Assessment of Drainage Proposals

55 Fitzroy Park, Camden

January 2021

Figure 9 - DRAINAGE LAYOUT OVERLAID ONTO PROPOSED LAYOUT

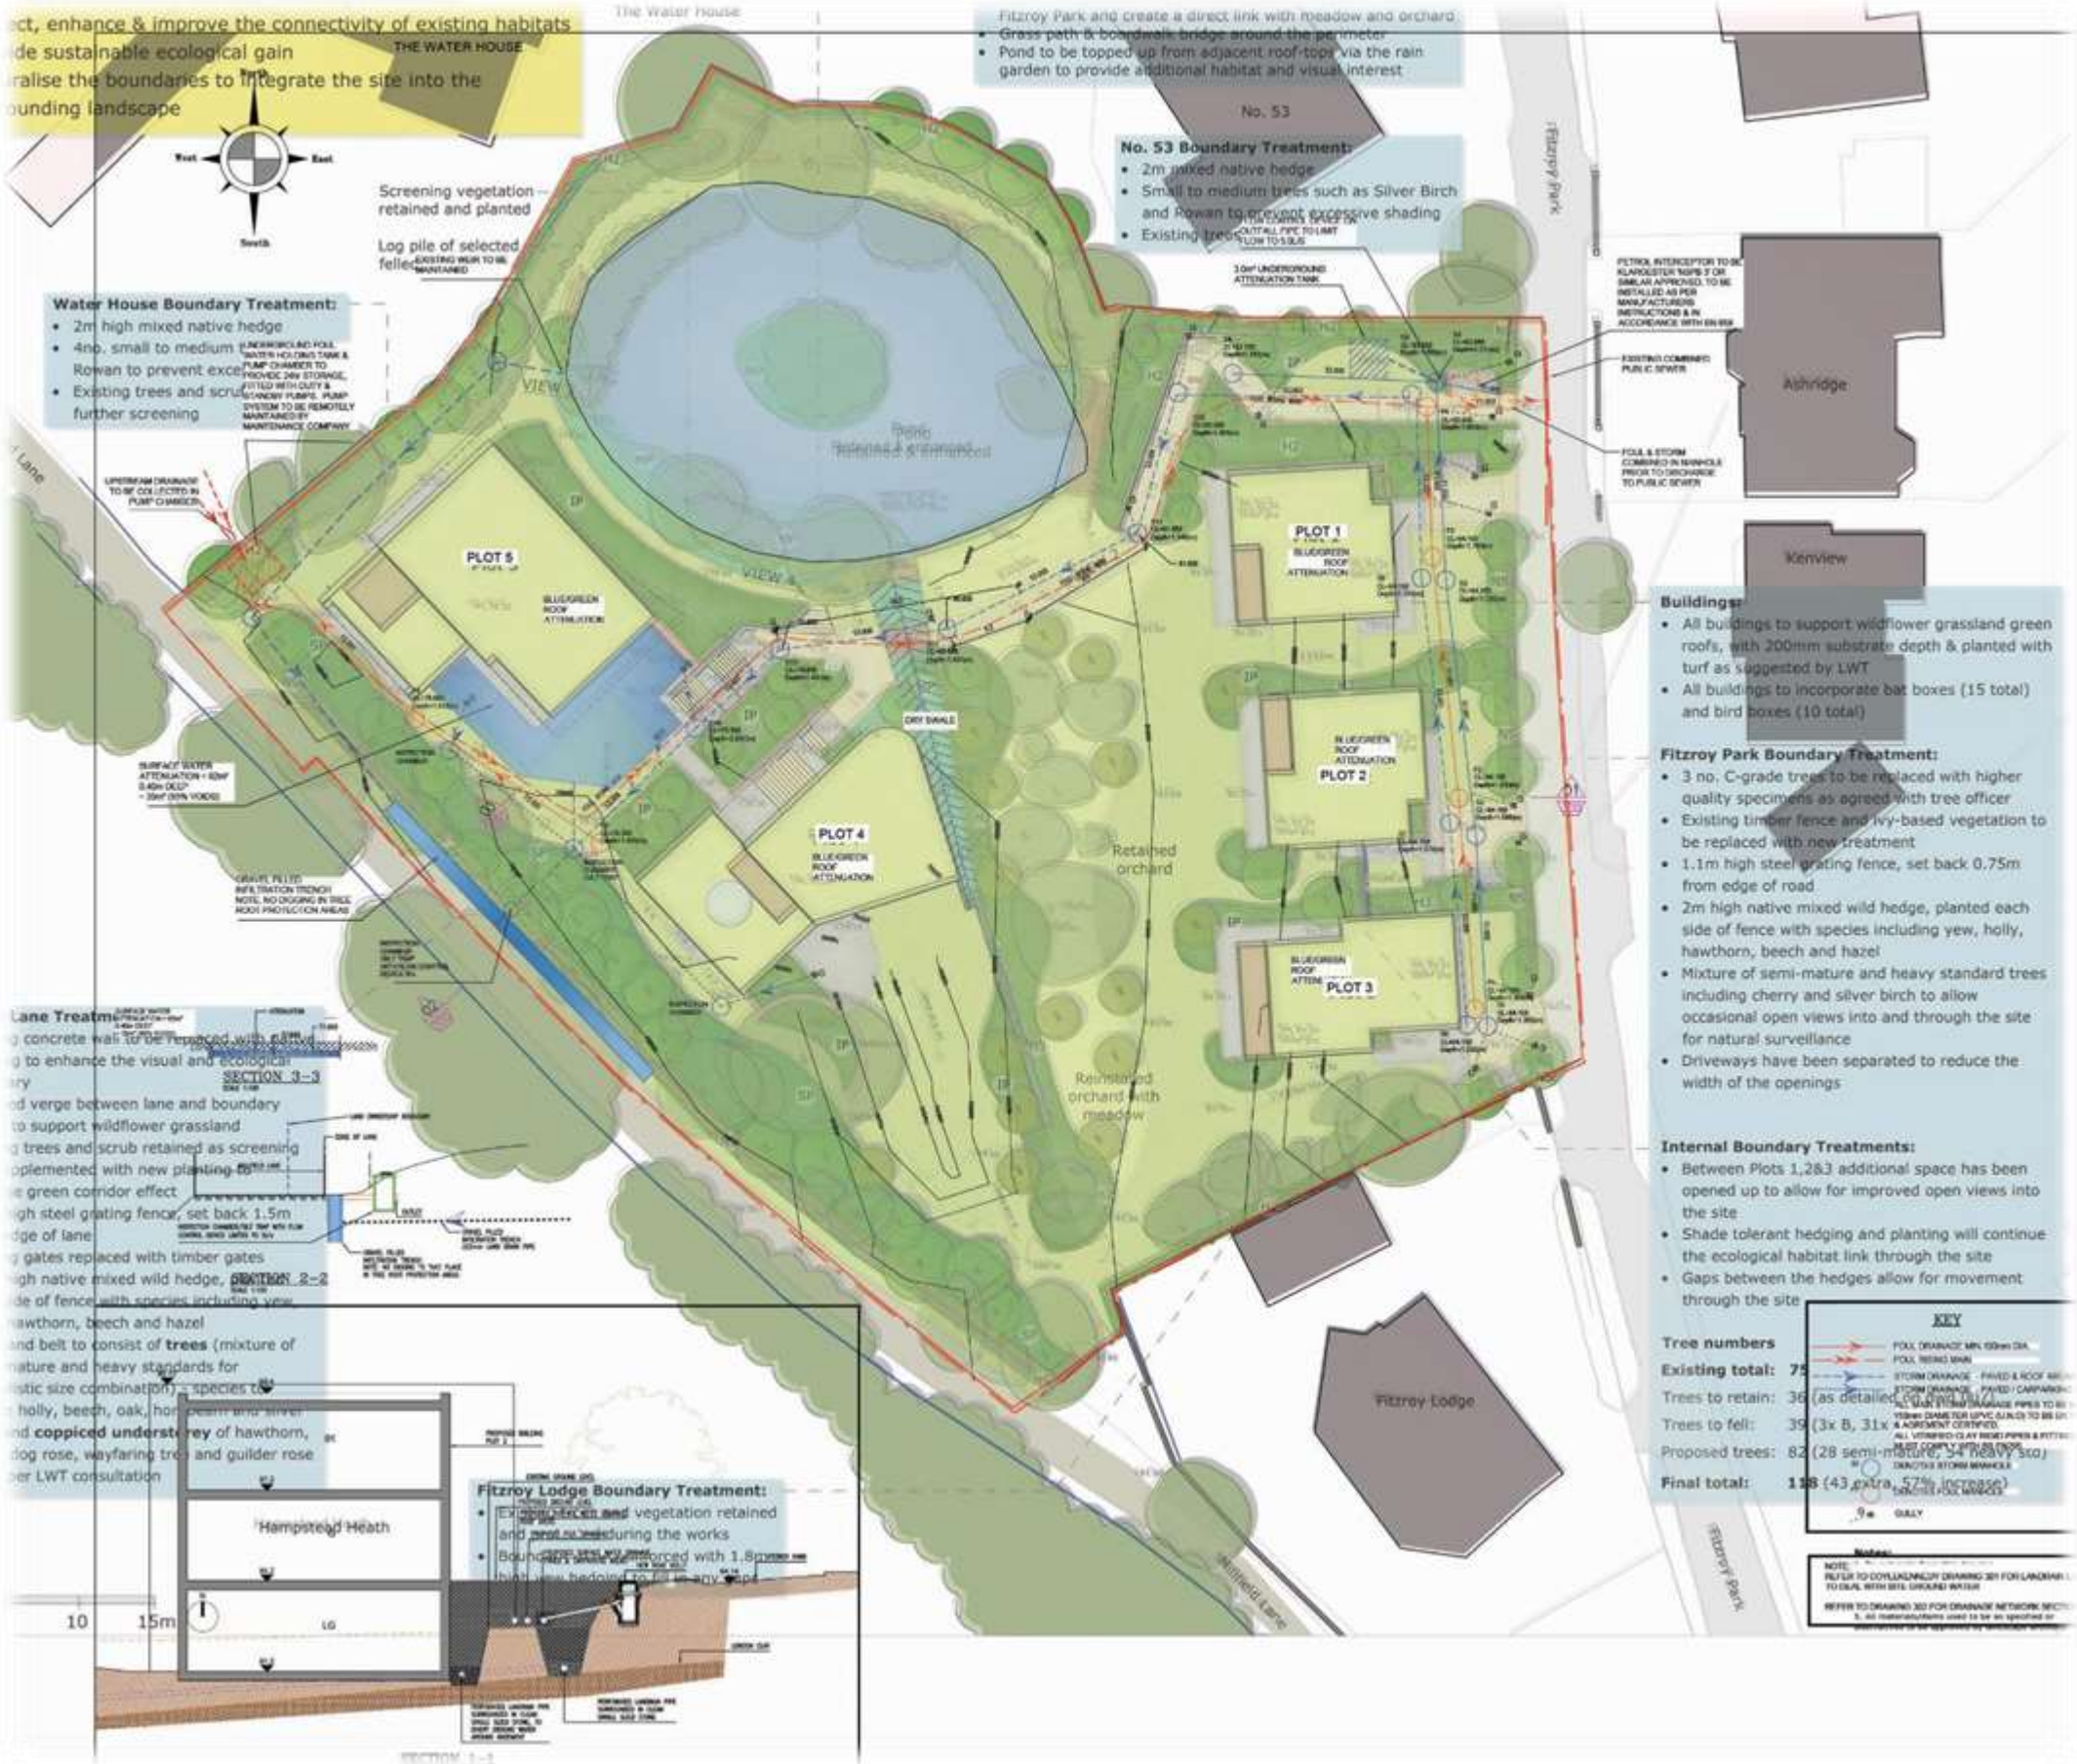
T563	Silver birch	4m	10m	Tree canopy and roots could potentially enter the easement area	
	T567	Ash	4m	20m	Tree canopy and roots could potentially enter the easement area	
Storm water pipework south of plot 4	T520	Walnut	6.5m	15m	Tree canopy and roots could potentially enter the easement area	
Proposed vegetation - Identified Conflicts						
Proposal	Proposed Vegetation reference	Species	Conflict			Reference
Storm drain pipework between the existing weir and the gravel trench	H2 hedge planting along north-western boundary	Hawthorn, Field Maple, Dog rose, Hornbeam;	Some of these species too close to easement / sewer			See Figure 9 of JFA overlays
	Tree planting indicated	Beech, Oak, Hornbeam, Silver birch, Holly and Rowan	Some of these species too close to easement / sewer			
Gravel/infill trench pipework to the south of plot 5	NS Native hedge planting along southern boundary	Holly, Yew, Hawthorn, Hornbeam, Beech and Hazel	Some of these species too close to easement / sewer

SP Structure planting along southern boundary	Hawthorn, Hazel, Dog rose, Wayfaring tree, Guelder rose	Some of these species too close to easement / sewer			
Foul and storm drains running alongside and behind plots 1 and 4	H2 hedge planting either side of access path	Hawthorn, Field Maple, Dog rose, Hornbeam;	Some of these species too close to easement / sewer			
	Tree planting indicated	Beech, Oak, Hornbeam, Silver birch, Holly and Rowan	Some of these species too close to easement / sewer			
	Orchard planting	Apple and plum varieties	Some of these species too close to easement / sewer

When the Proposed Drainage Layout is overlaid onto the Landscape Masterplan it is clear that the proposed tree and larger shrub planting that falls within the sewer easements would not be achievable.
